Final Environmental Assessment
Utah Coal and Biomass Fueled Pilot Plant
Kanab, Utah

DOE/EA-1870

December 2011

U.S. Department of Energy
National Energy Technology Laboratory

Figure 1-1. The NEPA Process

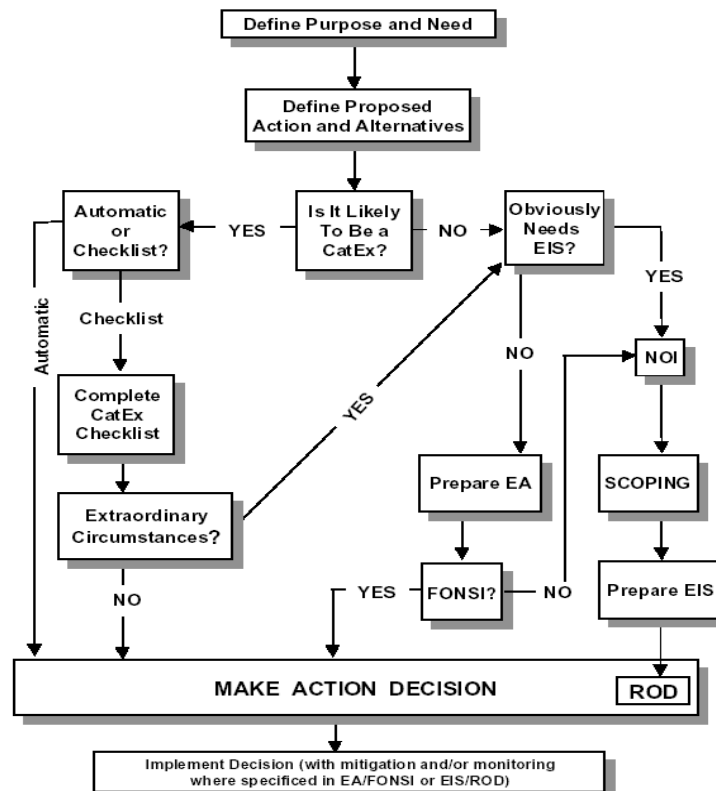
This EA is inadequate. A FONSI should not be issued, and the process should be moved to an EIS, in accord with figure 1.1 of the EA.

Figure 2-3. Conceptual Drawing of Pilot Plant

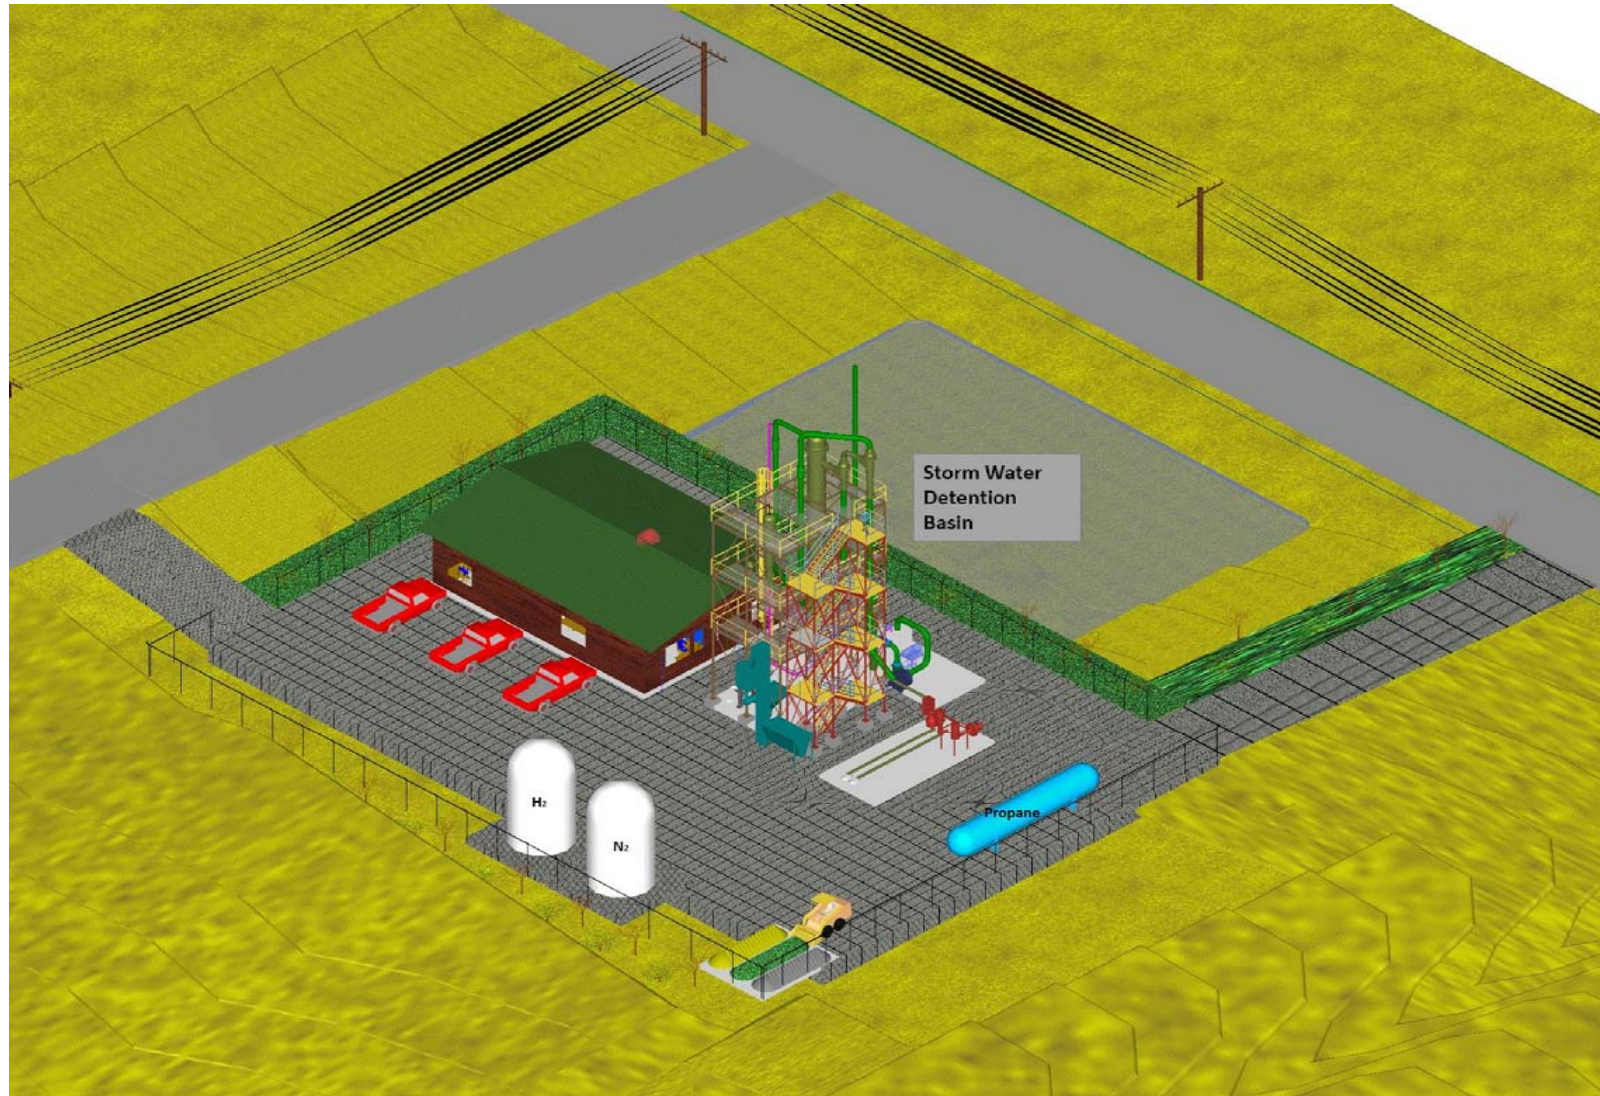
pond; no evaporation pond is discernable in Figure 2-3. Please explain what is meant by "returned to the environment". Would this effluent truly be left to evaporate in a pond?

Facility Processes and Equipment (Section 2.7.2.) makes no mention of an evaporation pond; no evaporation pond is discernable in Figure 2-3. Please explain what is meant by "returned to the environment". Would this effluent truly be left to evaporate in a pond?

Facility Processes and Equipment (Section 2.7.2.) makes no mention of an evaporation pond; no evaporation pond is discernable in Figure 2-3. Please explain what is meant by returned to the environment. Would this effluent truly be left to evaporate in a pond?

Facility Processes and Equipment (Section 2.7.2.) makes no mention of an evaporation pond; no evaporation pond is discernable in Figure 2-3. Please explain what is meant by "returned to the environment". Would this effluent truly be left to evaporate in a pond?

Section 2.7.2 and Figure 2-4 cover Viresco's operational plans as implemented under the proposed action (30-day); the evaporation pond discussed in Section 5.2 refers to one of Viresco's options in handling

Figure 2-4. Utah Coal and Biomass Fueled Pilot Plant Processes

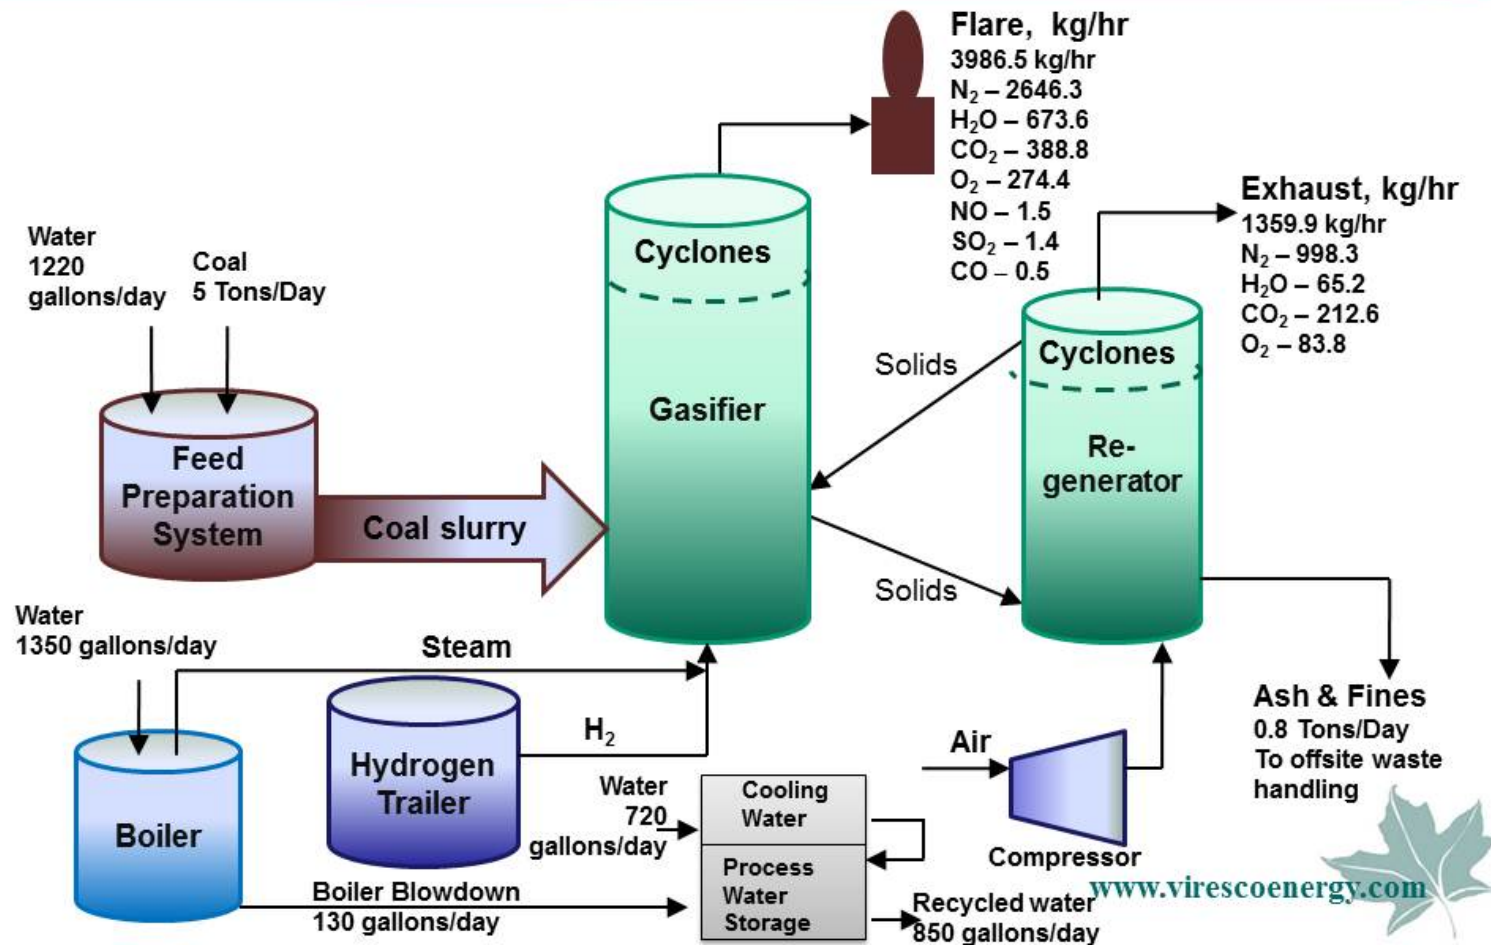
- 6-03** Figure 2-4 shows that 100% of the exhaust from the cyclone re-generator is nitrogen, water, carbon dioxide and oxygen. Do you really believe there won't be any toxic compounds, methane gas, or other substances released into the air?

- 15-11 P 15 par3:
Information about potable water use contradicts itself and seems intentionally misleading within the table and in the illustration (Figure 2-4) and paragraphs on p 15. Separating potable vs. non-potable water makes no sense since the paragraph states that ALL water will be supplied by Kanab's potable water system:

- Process water ... 1,270 gpd for a total of 38,100 gallons for 30 days of operation.
 (Figure 2-4 shows 1320 gpd.)The daily potable water demand by the Pilot Plant when it is operational would be limited to the needs of a workforce of 9 employees at 250 gpd for a total of 7,500 gallons for 30 days of operation. Both the process water and the potable water would be supplied by the City of Kanab's potable water system. The total daily rate of potable water use (1,520 gpd) (according to the diagram this figure should be 1370) represents 0.03 percent of the existing wells and spring capacity that supply the City of Kanab's potable water system.

1. On page 16, section 2.7.2 and page 17, Figure 2.4 include an air compressor for the regenerator. This compressor is not addressed in the emission calculations. Please verify that this compressor is electrically-powered and not run on hydrogen or propane.

"Most notable emission would be of carbon monoxide and is estimated to be less than 16 tons for 130 days of operation." Yet Per figure 2-4, Flare emits 9183 lbs/hr= 5 tons/hr!

Total process water demand (non-potable use) for the Pilot Plant under the proposed action would be approximately 3,290 gpd, potentially all of it supplied from the City of Kanab. It is anticipated that up to 850 gpd would come from recycled water from other plant processes, which could reduce the process water demand to 2,440 gpd. Additionally, it is estimated that employees of the facility would use 250 gpd of the City's water (potable water use). Section 2.7, including Table 2.7-1 and Figure 2-4, has been revised to clarify water demand and source of the water supply.

Section 2.7.2 and Figure 2-4 cover Viresco's operational plans as implemented under the proposed action (30-day); Section 2.8 discusses operational plans considered under the connected action (130-day maximum). See response to comment number 39-04 regarding the statement "returned to the environment."
